## Addendum #3

**Project Name:** Cattle National Bank & Trust - Fallbrook  
6550 Merchant Drive  
**Project No.:** 12054  
**Issued:** May 09, 2013  
**Bid Date:** 2:00 pm, CDT May 14, 2013

Revision to Detail **E1/A401**

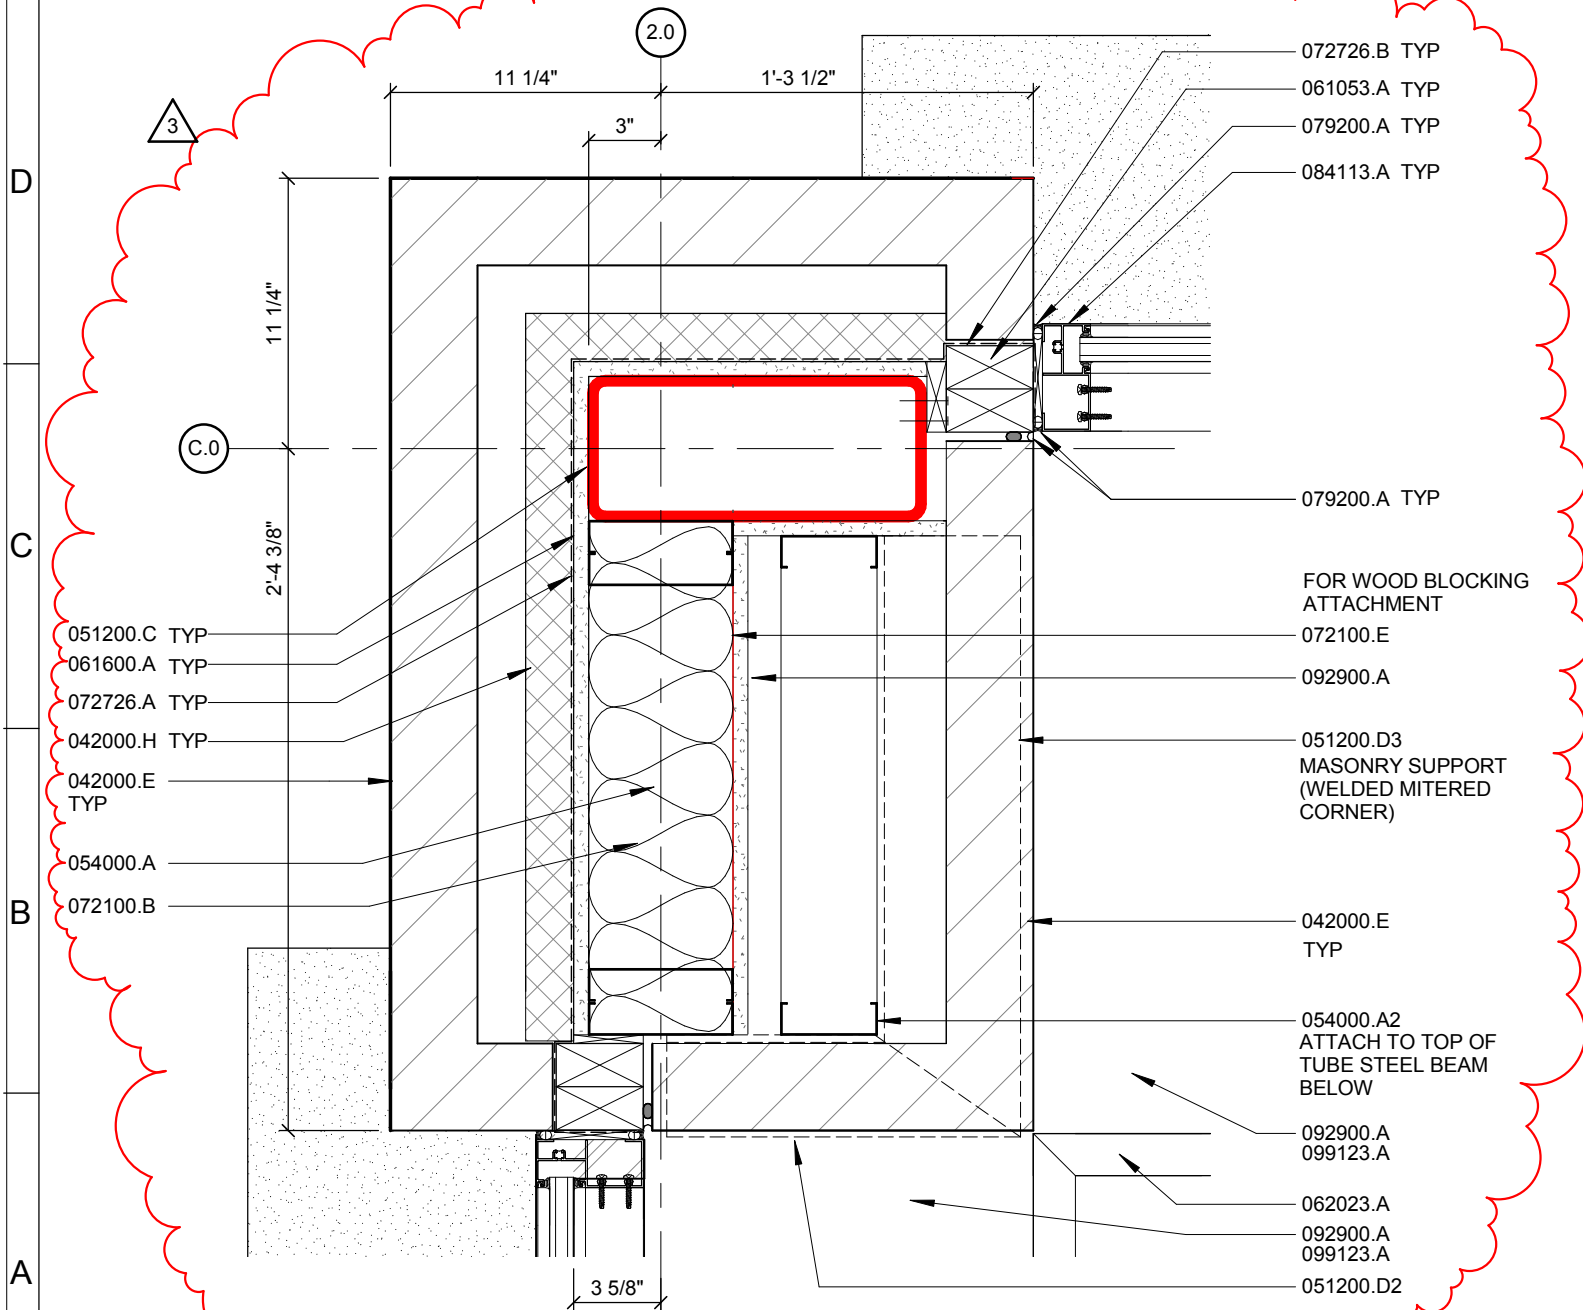
- a. A1/A401: Revised detail. Added keynotes, dimensions and support for interior masonry. Refer to Attachment A07.
- b. E1/A401: Coordinated drawing with structural for brick support. Added keynotes. Refer to Attachment A08.
- c. K4/A401: Revised note to be consistent with the rest of the documents. Teller Window and Teller Drawer are owner provided and installed in coordination with contractor. Refer to Attachment A09.

Revision to Detail **A10/A502**

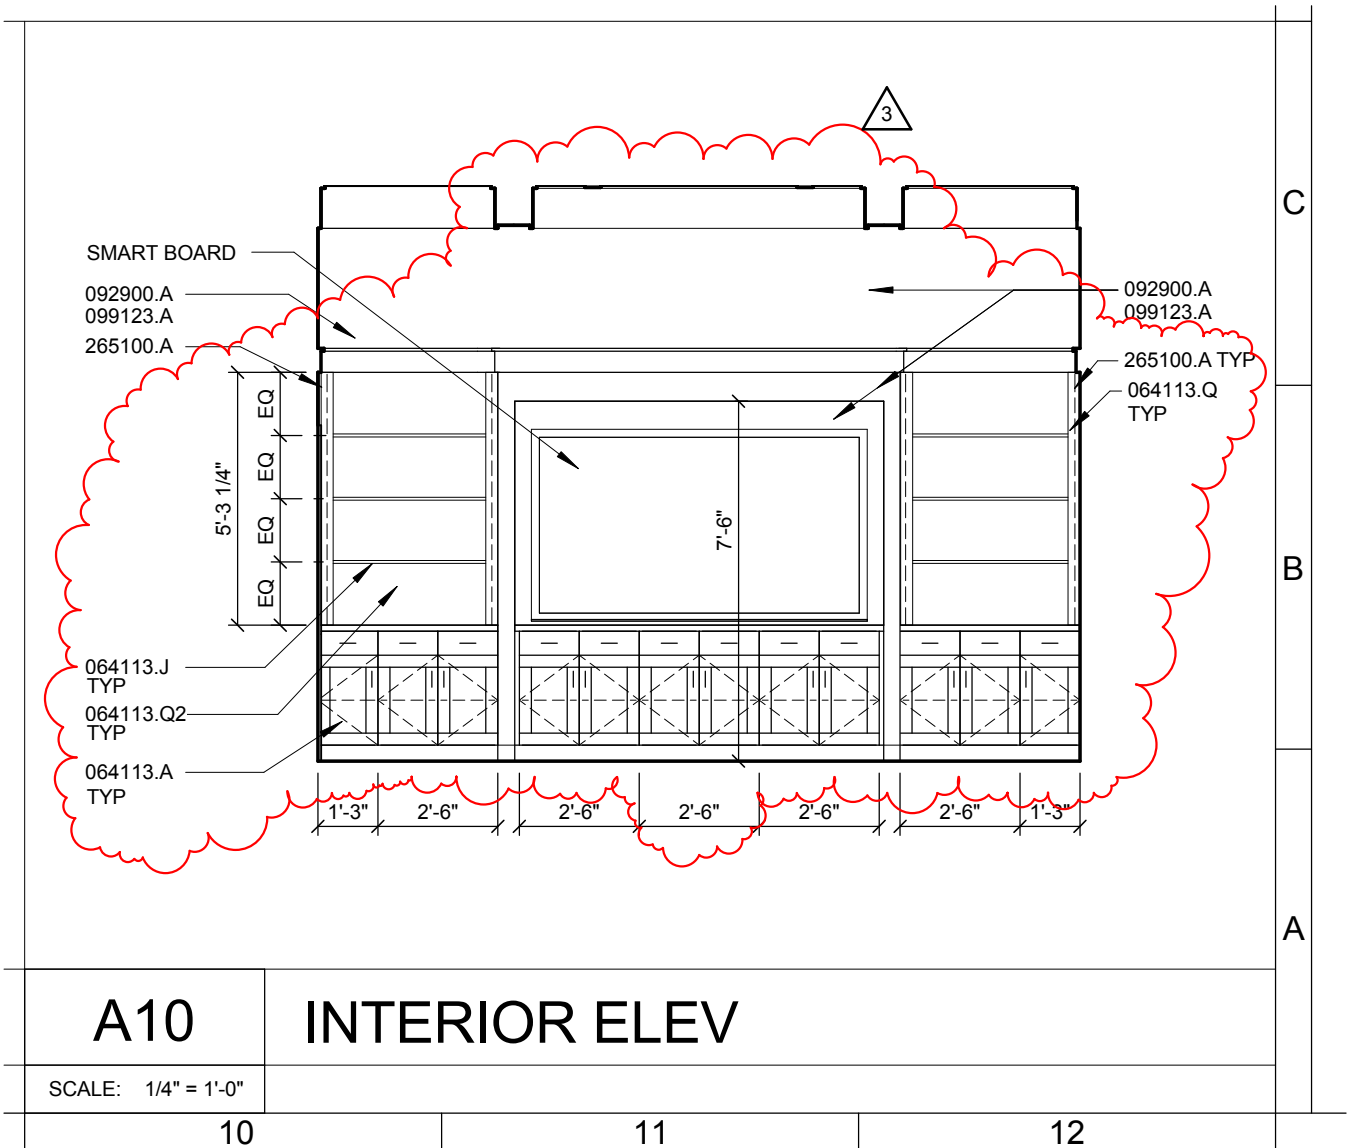
- a. Revised walls around smartboard. Revised cabinetry to show trim on cabinet doors. Added two additional shelves. Added keynotes and revised a dimension. Refer to Attachment A12.

**A503**

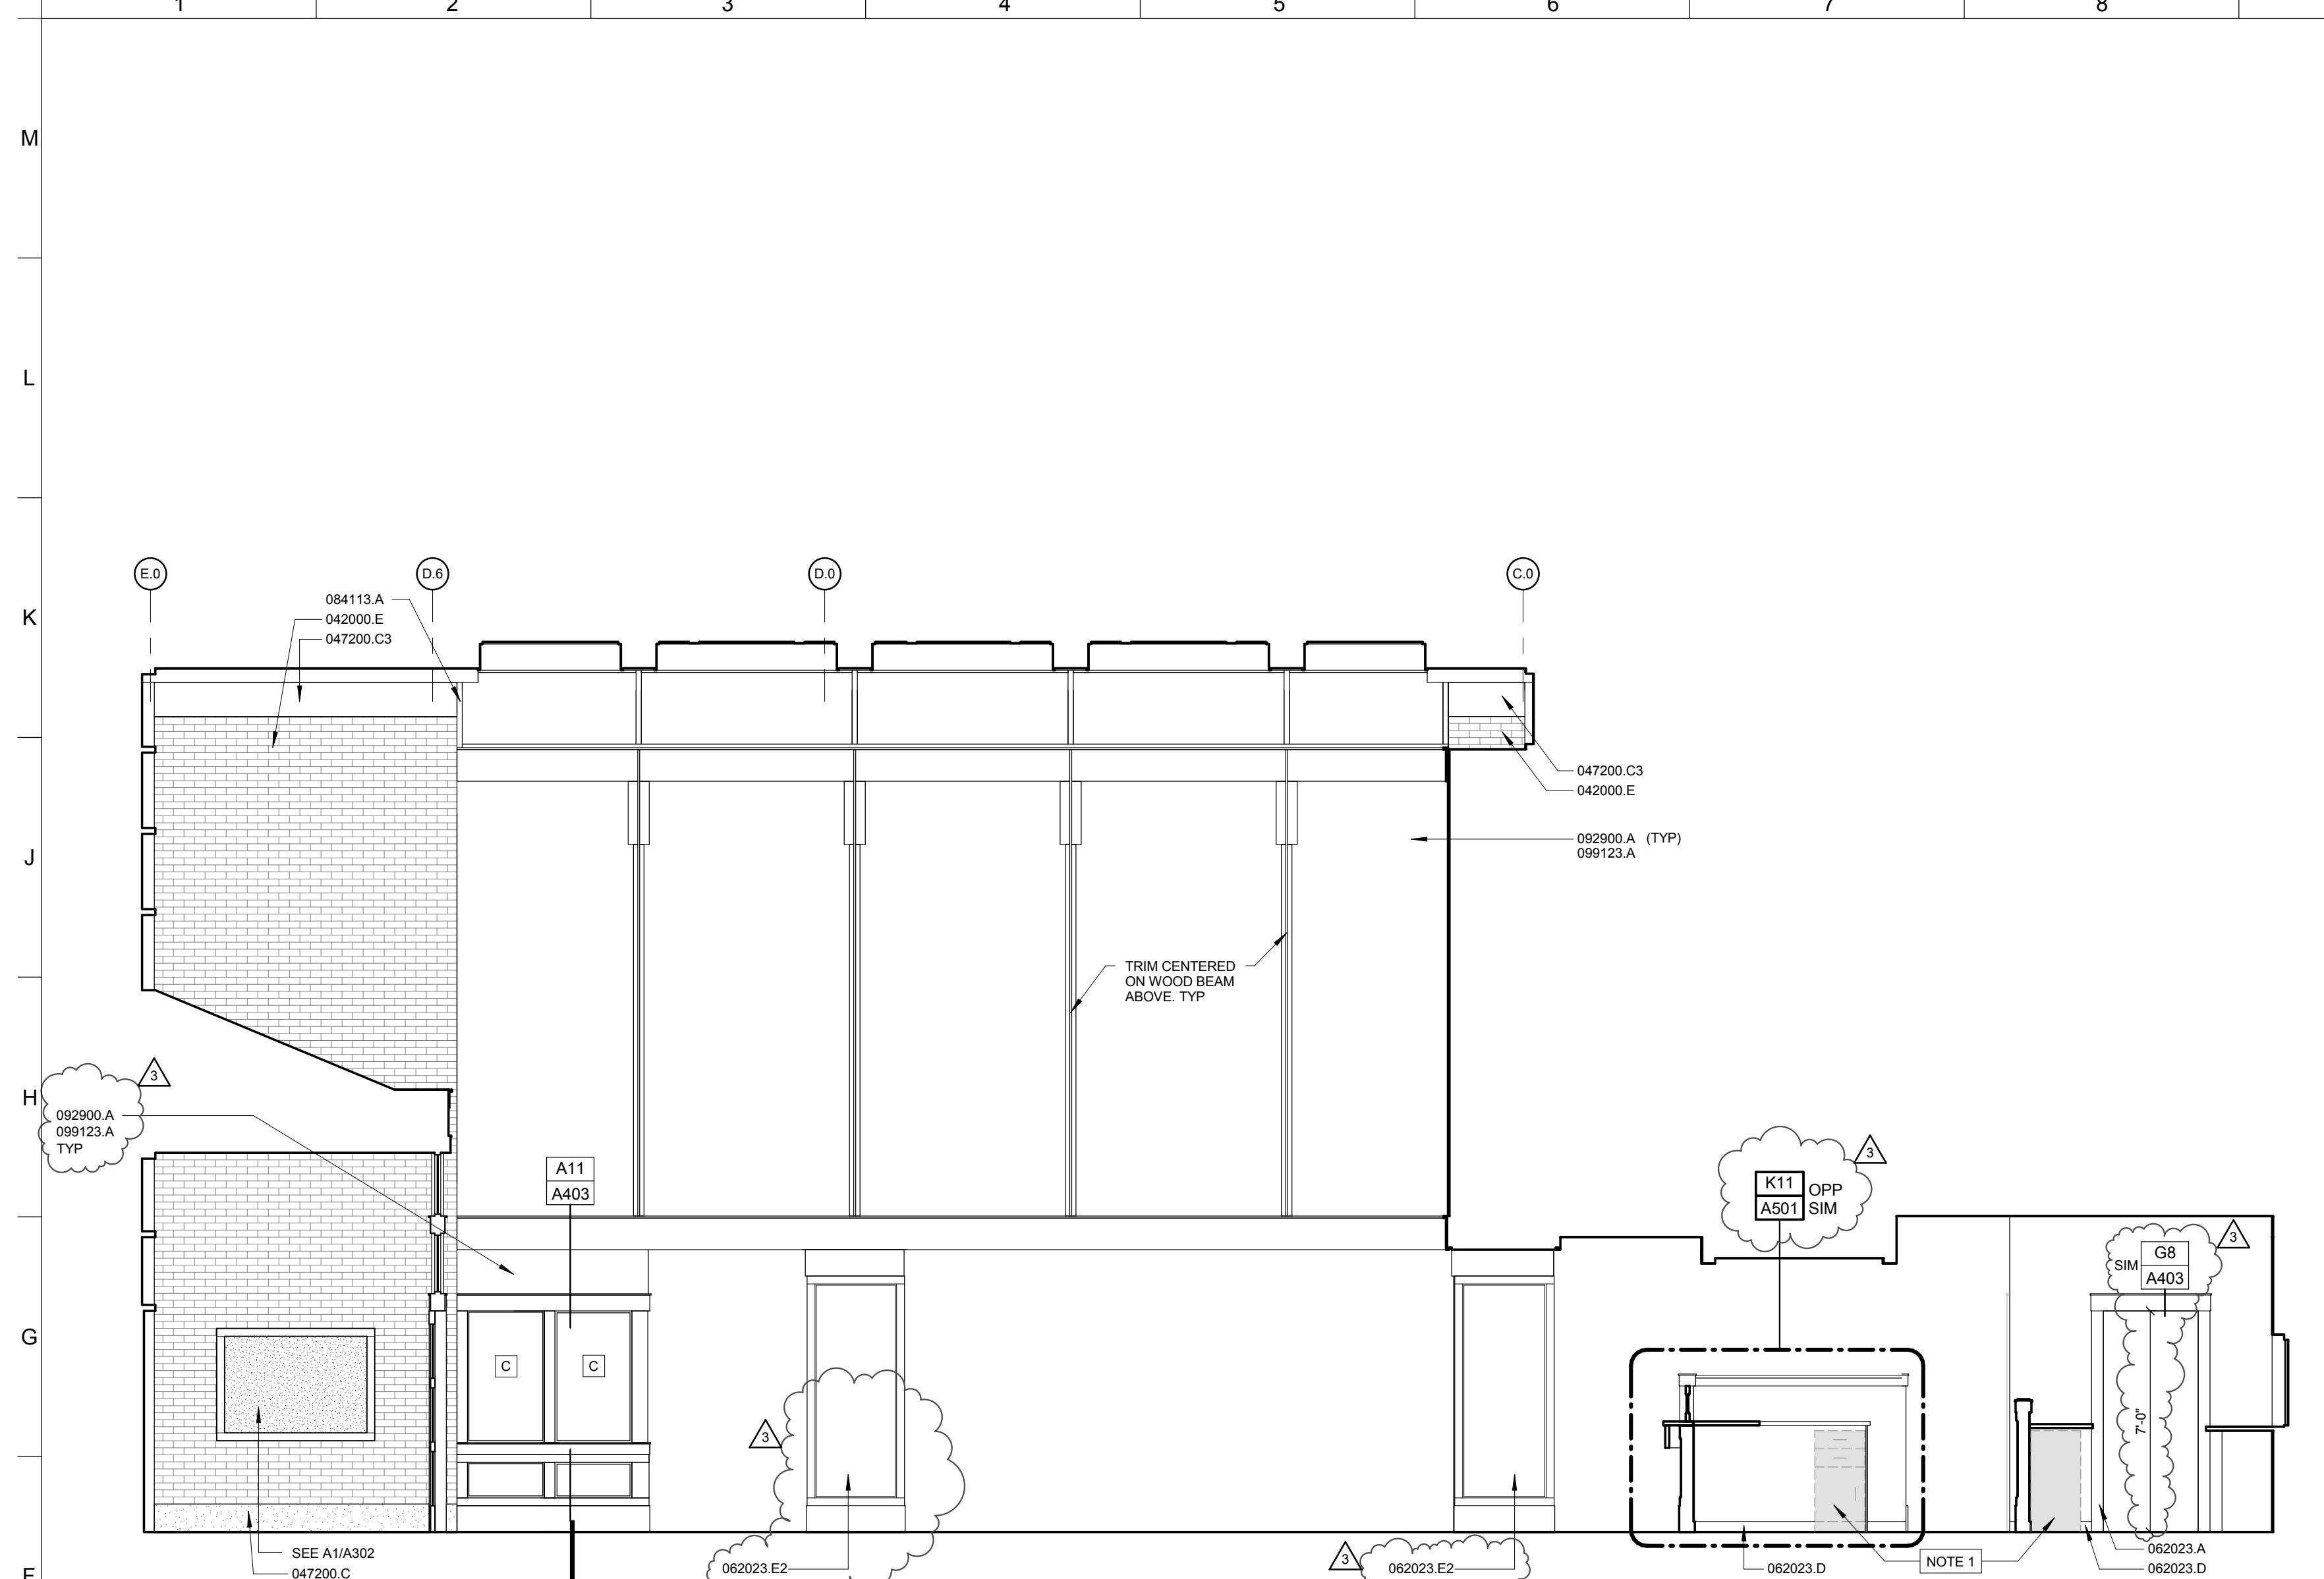
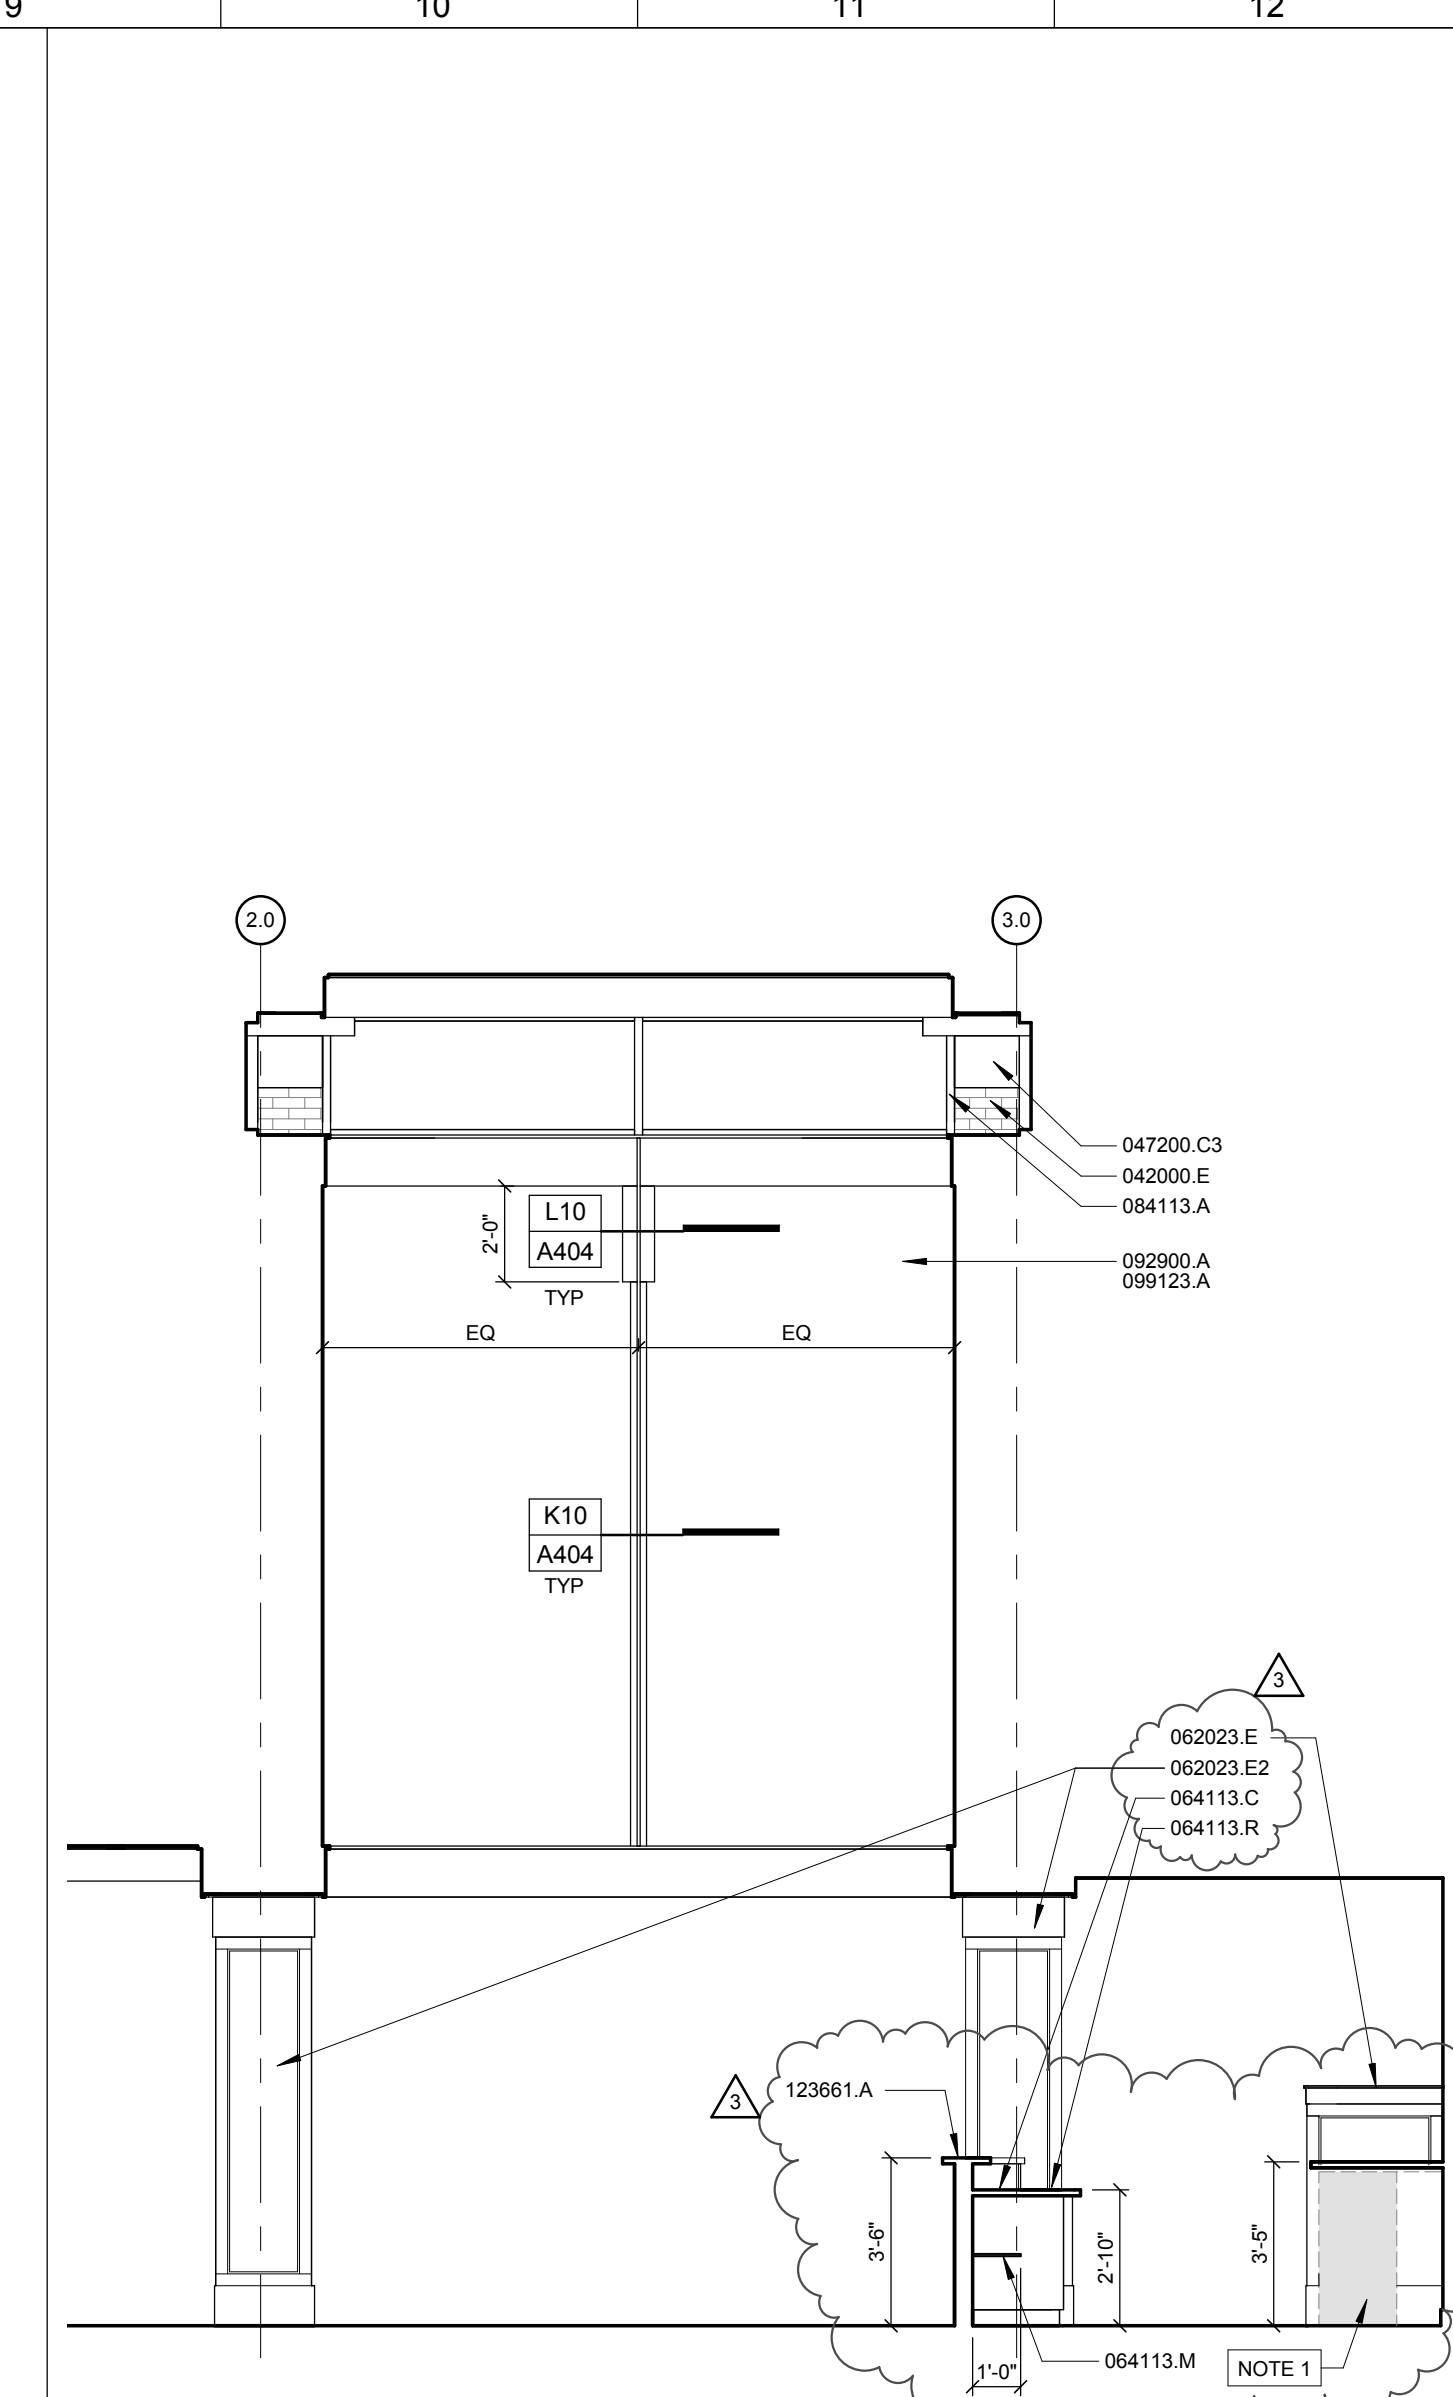
- a. F1/A503: Added keynote 062023.E2 to clarify scope. Added additional keynotes and callout tags to existing drawings. Refer to Revised Sheet A503.
- b. F9/A503: Added keynote 062023.E2 to clarify scope. Revised reception desk section and back counter section. Added additional keynotes and dimensions. Refer to Revised Sheet A503.
- c. A1/A503: Added keynote 062023.E3 and 062023.E2 to clarify scope of woodwork. Added callout tag of existing drawing, removed section tags at wood columns. Refer to Revised Sheet A503.
- d. A9/A503: Added keynote. Refer to Revised Sheet A503.
